**ADVERTISEMENT FOR BIDDERS**  
**for**  
**OLD BALLGROUND SANITARY SEWER REPLACEMENT PHASE 2 AND**  
**ETOWAH RIVER TRAIL EXTENSION**

**AUGUST 28, 2020**

**ADDENDUM NO. 2**

SHEET NO.  
**S-01**  
100065927

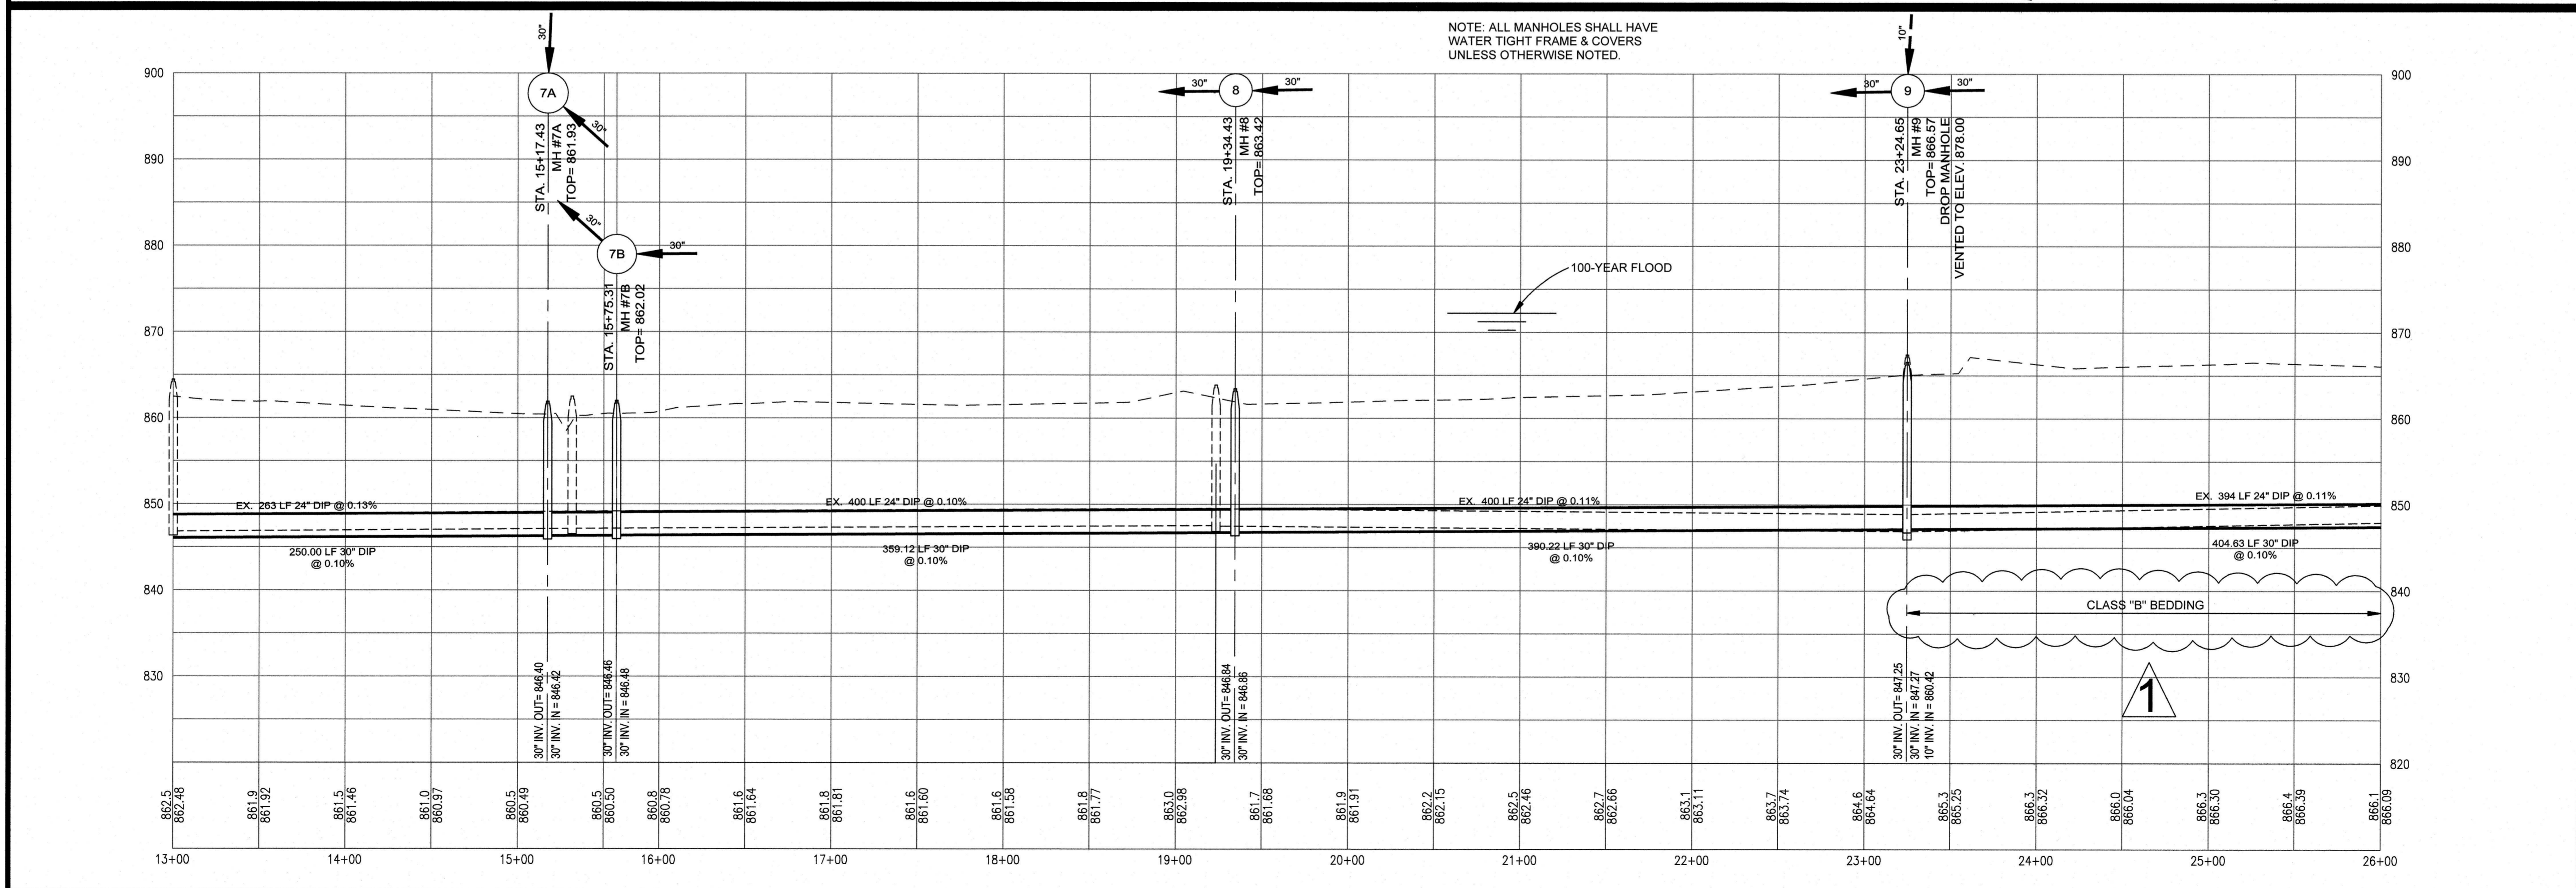
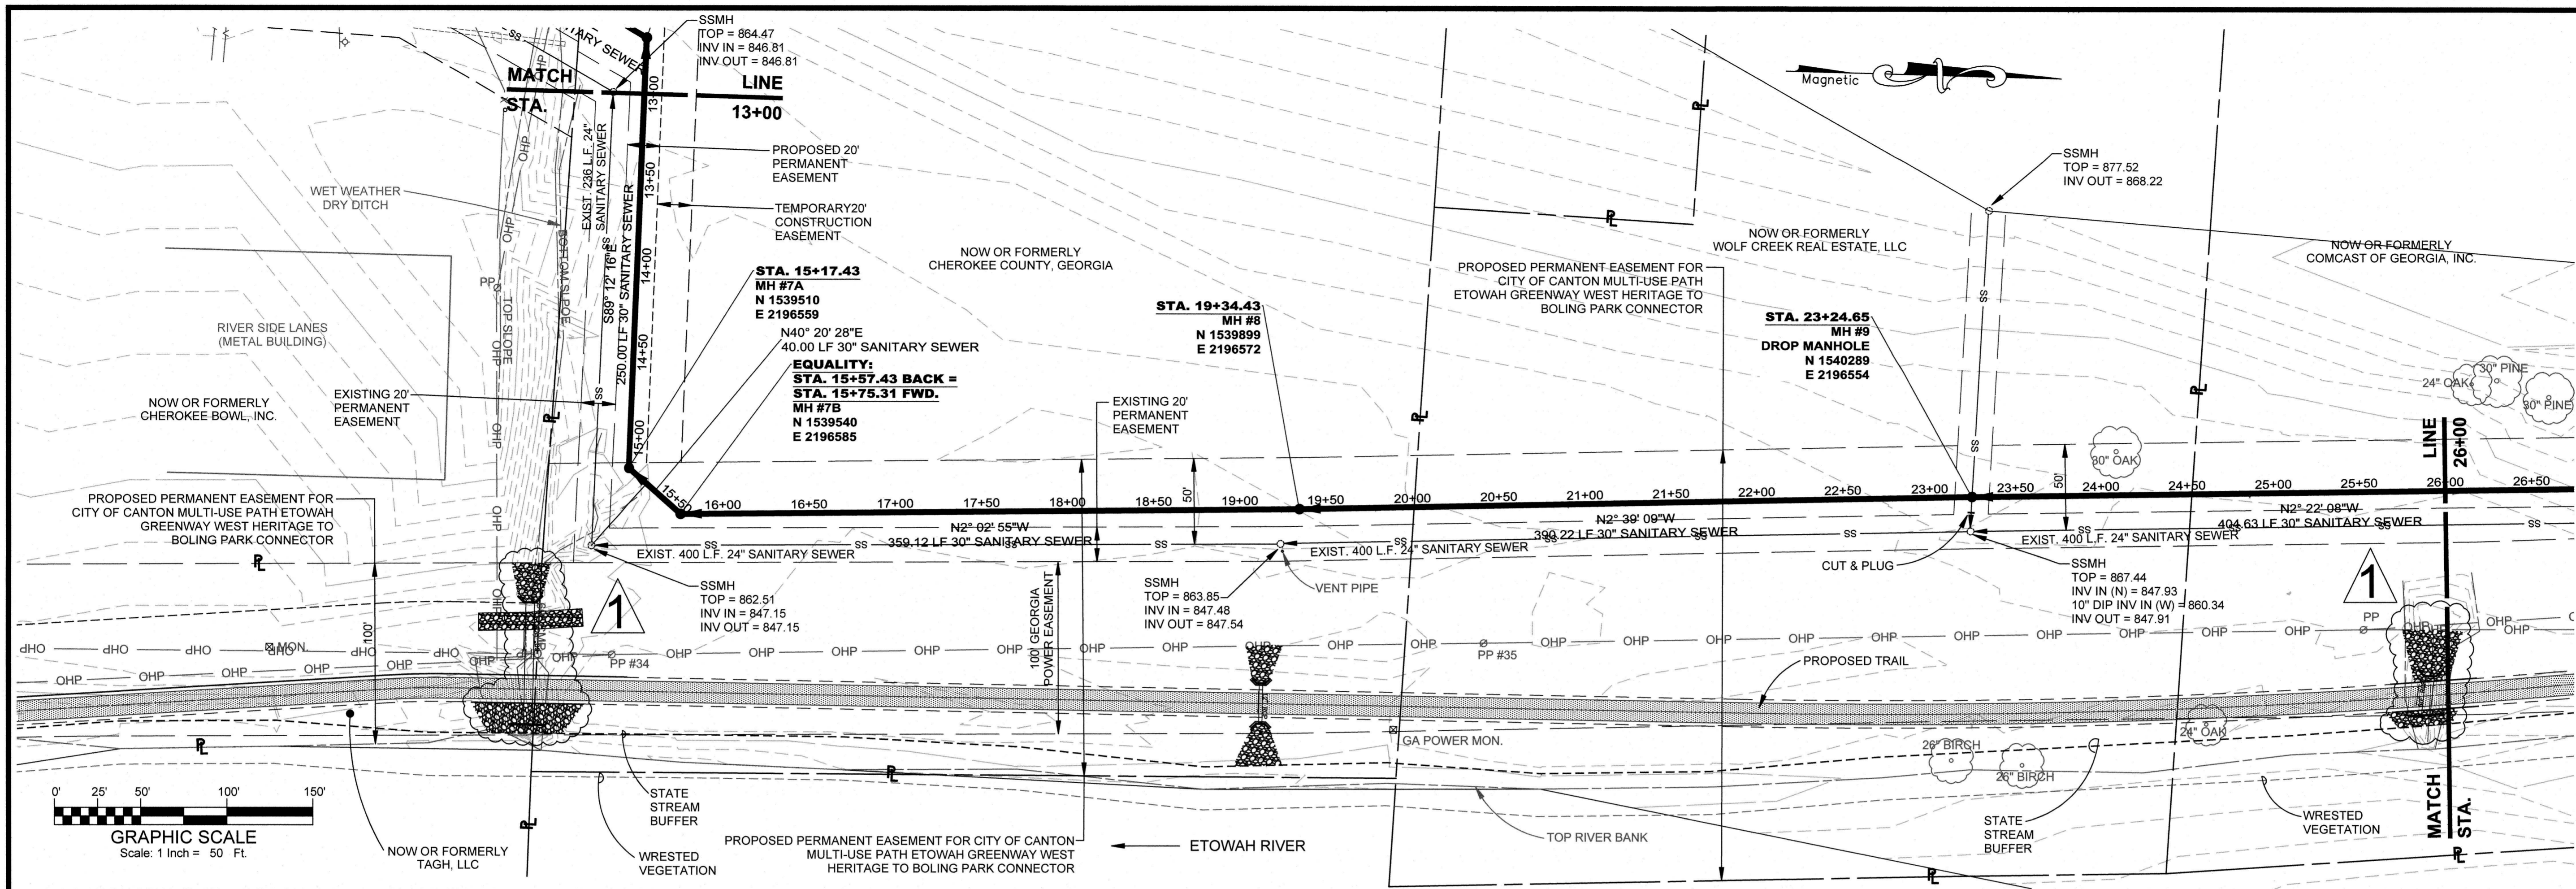
121. Bid Item 45 is for 10" DIP force main. The force main on Sheet S-01 is 16" DIP. Please clarify which is correct. Also, how long can the force main be out of service? **The existing force main is a 16". This Bid Item has been revised on the Bid Form to 16". Bypass pumping or support for the existing 16" force main will be required during construction in this area.**

122. Drawing sheet S-01 shows an existing manhole that is to be raised. How will the Contractor be compensated for raising this manhole? **Bid Item 25, Extra Depth Manhole 12+ Ft., in Vertical Feet.**

156. On Sheet S-01 between Stations 5+50 and 11+50, there is a good bit of curb and gutter that will need to come out because of the depth of the line. How will the curb and gutter/asphalt in this area be paid for? **See Bid Item 52 Remove and Replace Concrete Curb & Gutter 1240 LF and Bid Item 50 Remove and Replace 1-1/2” Type F Asphalt 5600 SY in the Addendum Two Bid Form.**

SHEET NO.  
**11-05**

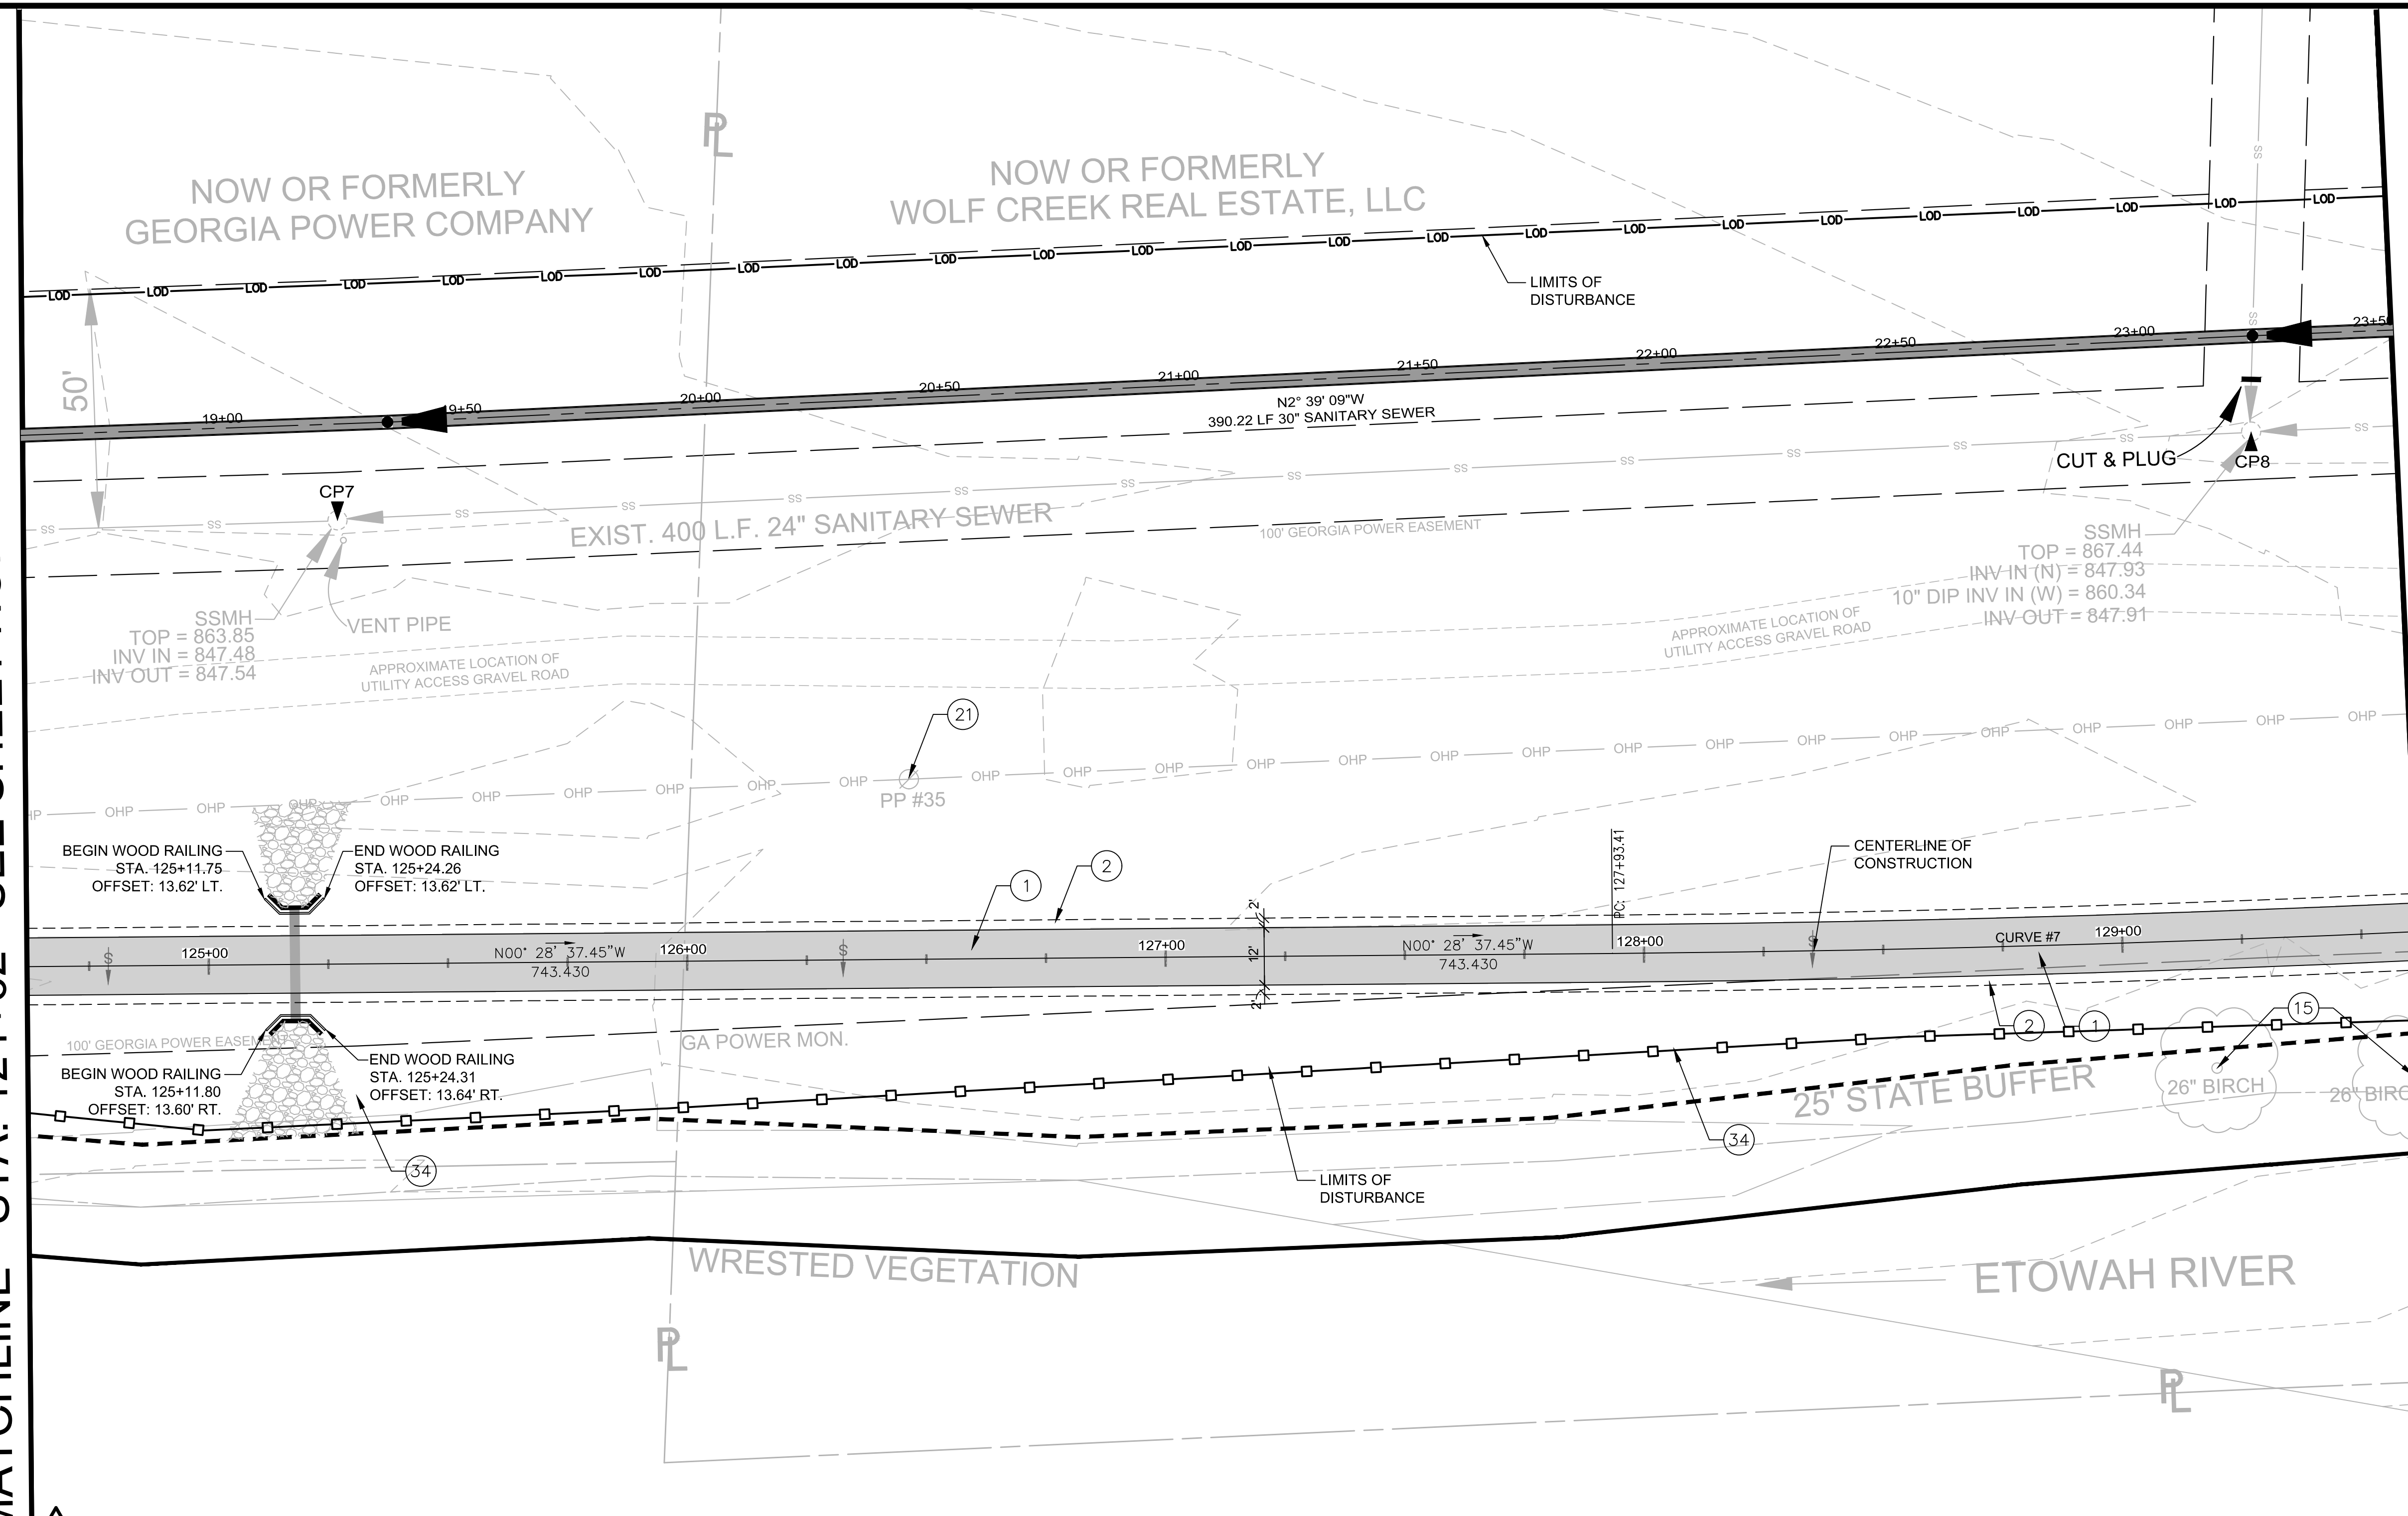
132. Please provide a copy of the GUPS encroachment agreement for Georgia Power with the bid documents. This would be beneficial for the safety requirements noted on Drawing Sheets 11-04 through 11-06. **Safety Note has been revised and final encroachment agreement will be provided to the Contractor upon completion.**
